### ADDENDUM 1

## Austin Elementary School Heating & Air Condition (HVAC) Improvements Funded through the Elementary & Secondary Emergency Relief (ESSER) Funds May 31, 2022

## Addendum

**PROJECT** 218007.004 | Edinburg CISD - Stephen F. Austin ES - HVAC Improvements

LEVEL 1  
ELECTRICAL  
POWER PLAN

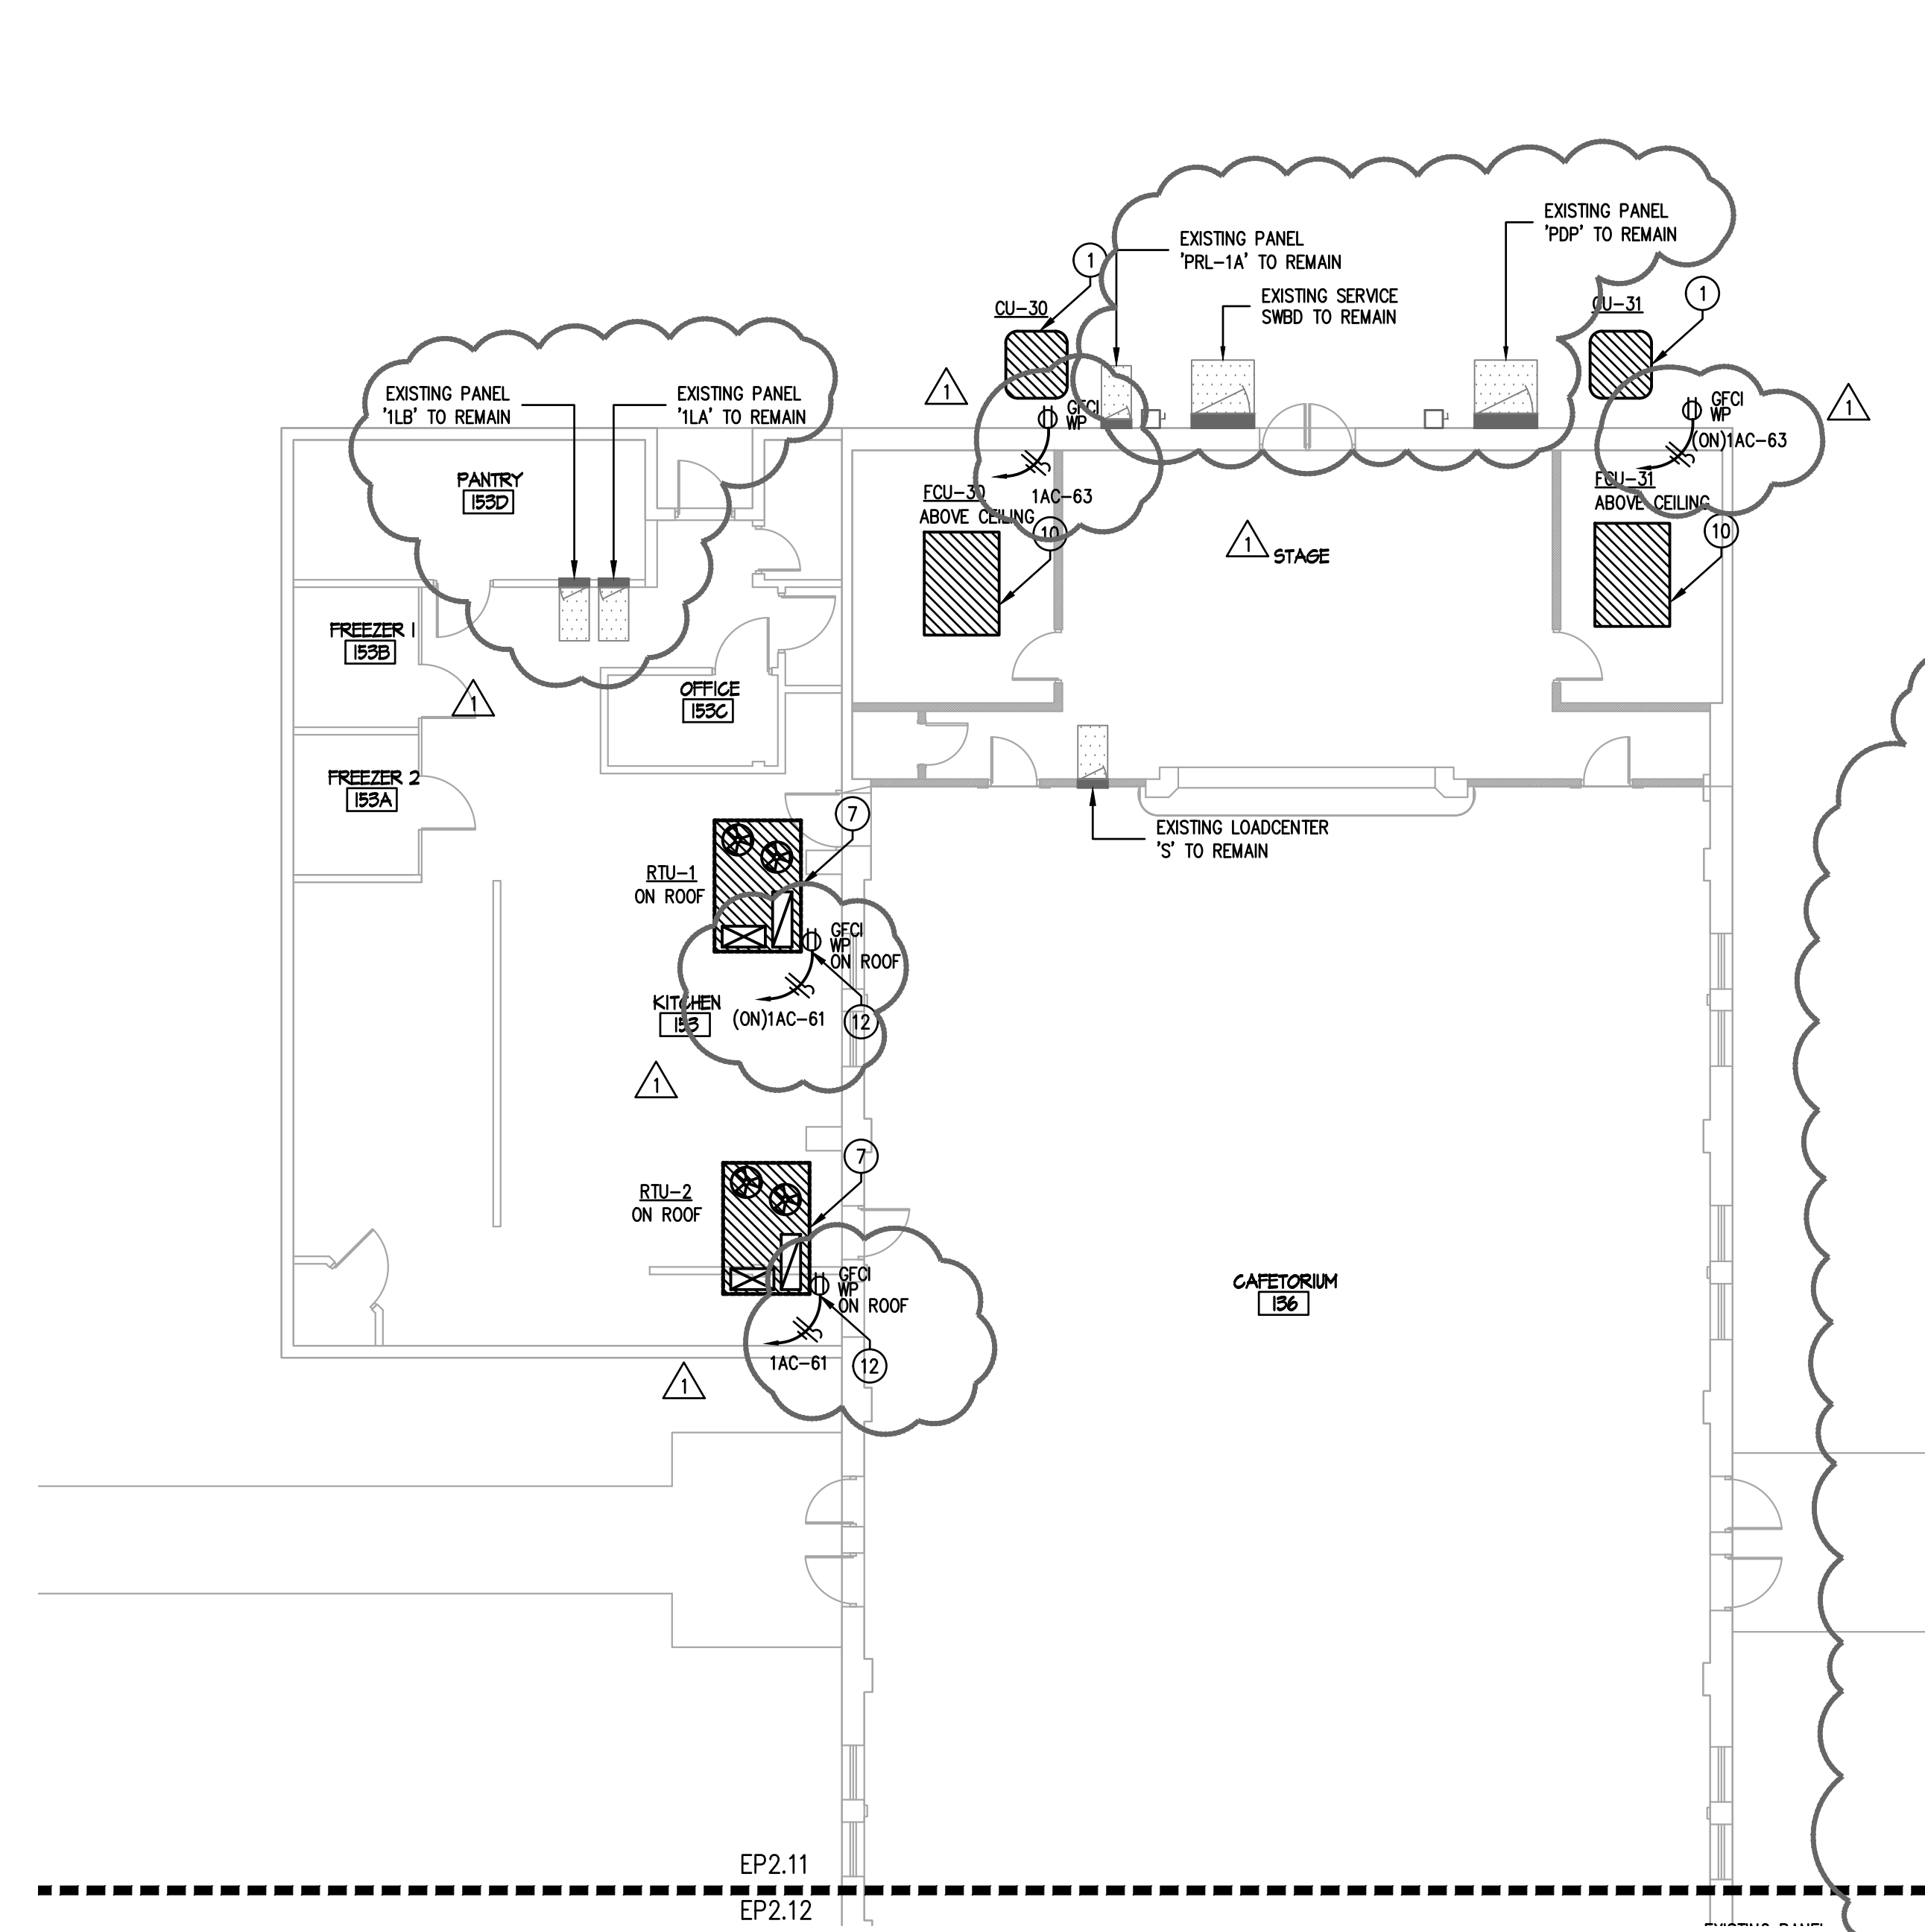
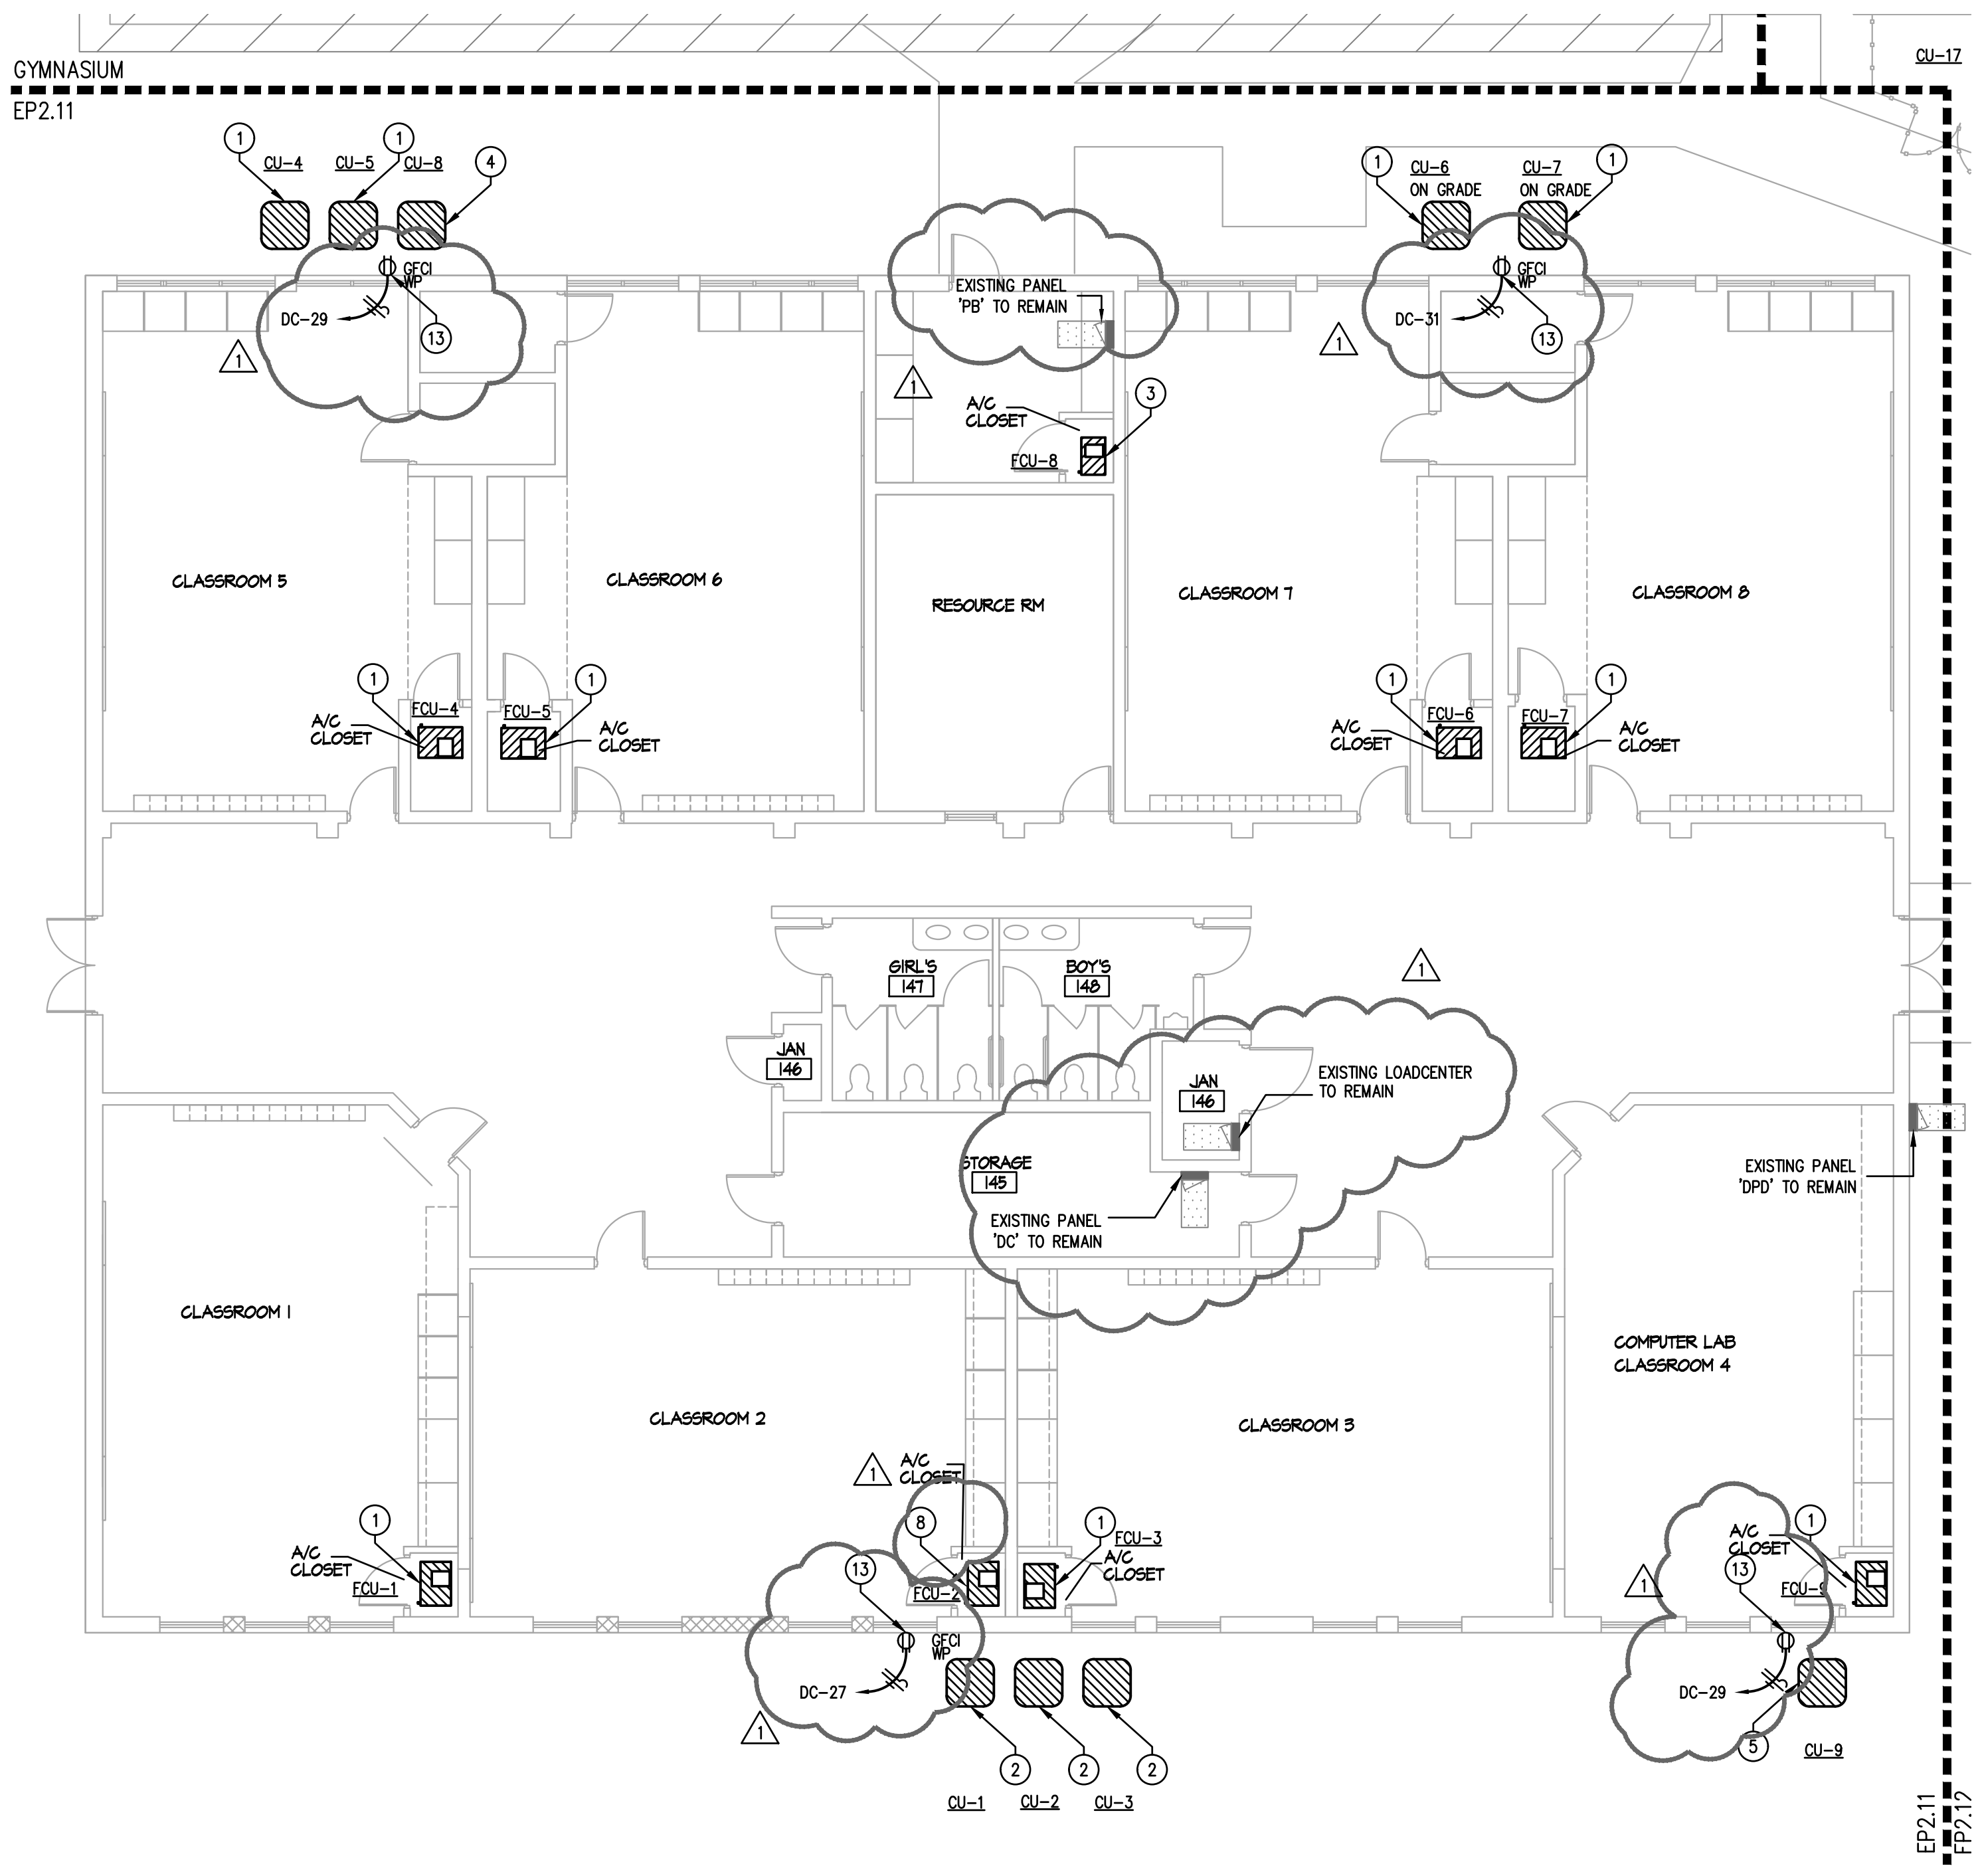
**Item 17 EP2.11 – LEVEL 1 ELECTRICAL POWER PLAN**

- A. Revised keyed notes.

- B. Revised noted equipment.
- C. Added maintenance receptacles for equipment.
- D. Added existing panel locations

DATE:	05/05/2022
DRAWN BY:	DBR
CHECKED BY:	DBR
PROJECT NUMBER:	218007.004
SHEET TITLE:	LEVEL 1 ELECTRICAL POWER PLAN - MAIN BUILDING
SHEET NUMBER:	EP2.12

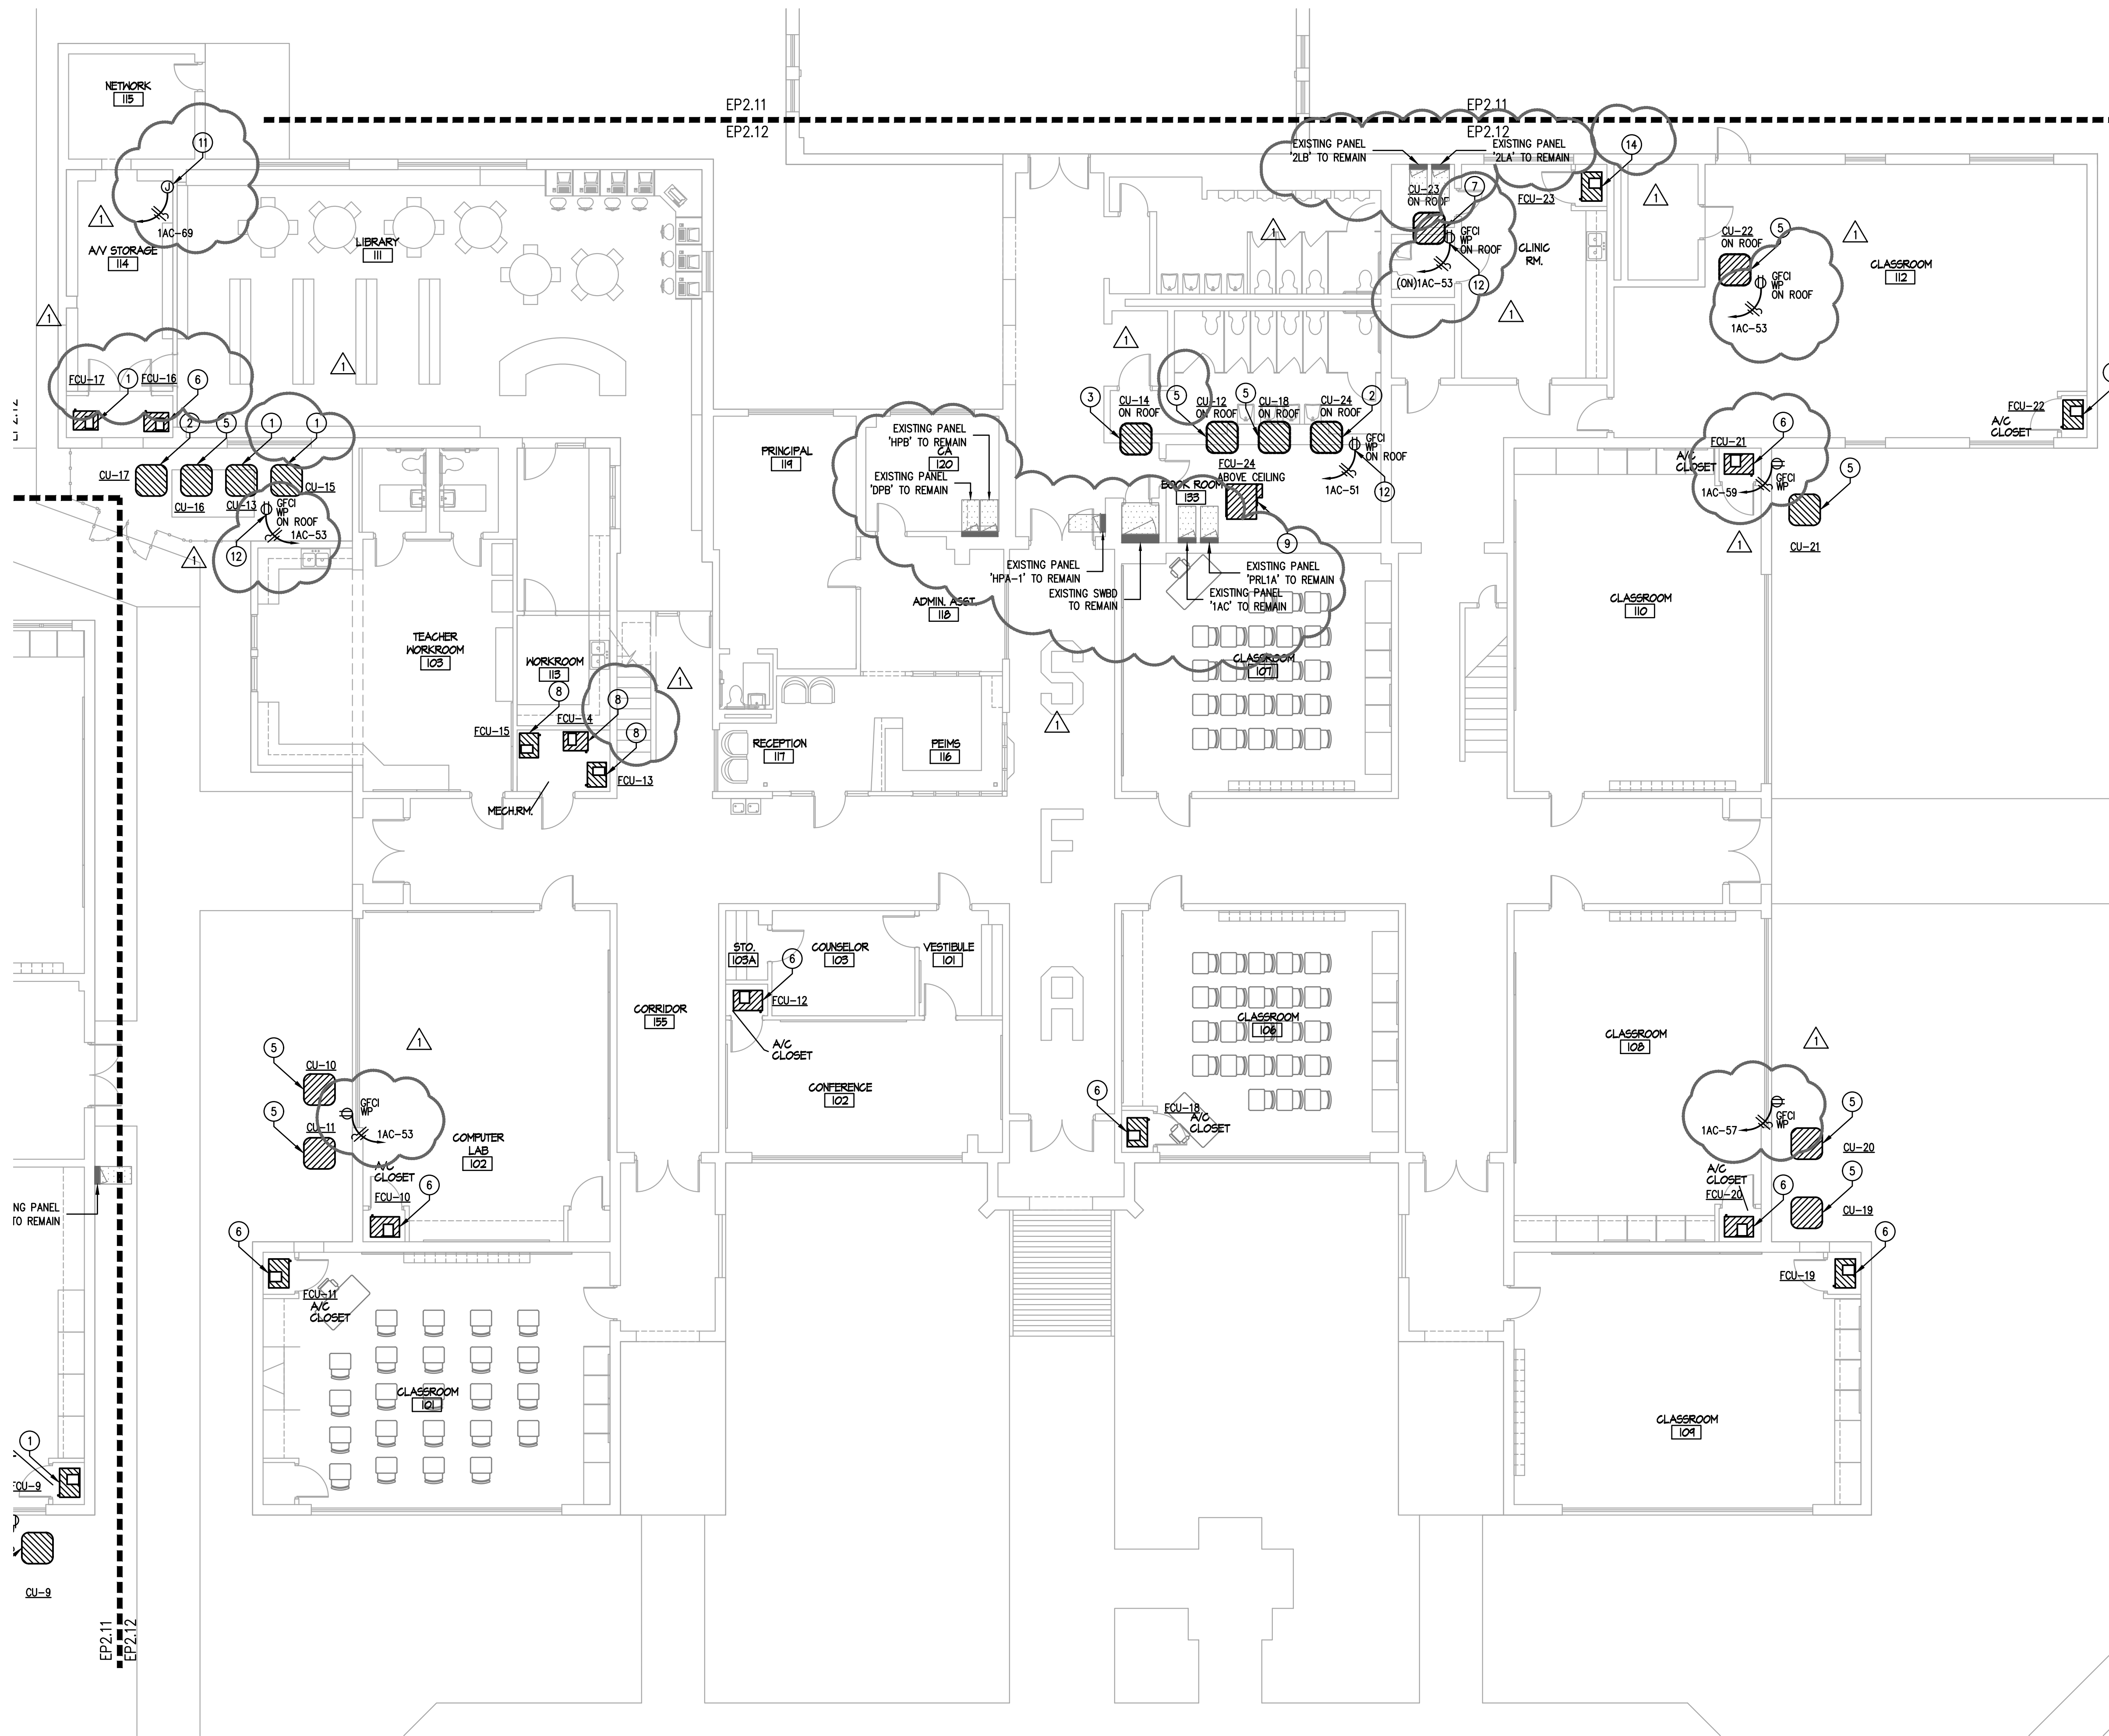
**Item 18 EP2.12 – LEVEL 1 ELECTRICAL POWER PLAN – MAIN BUILDING**

- A. Revised keyed notes.
- B. Revised noted equipment.
- C. Added maintenance receptacles for equipment.
- D. Added existing panel locations
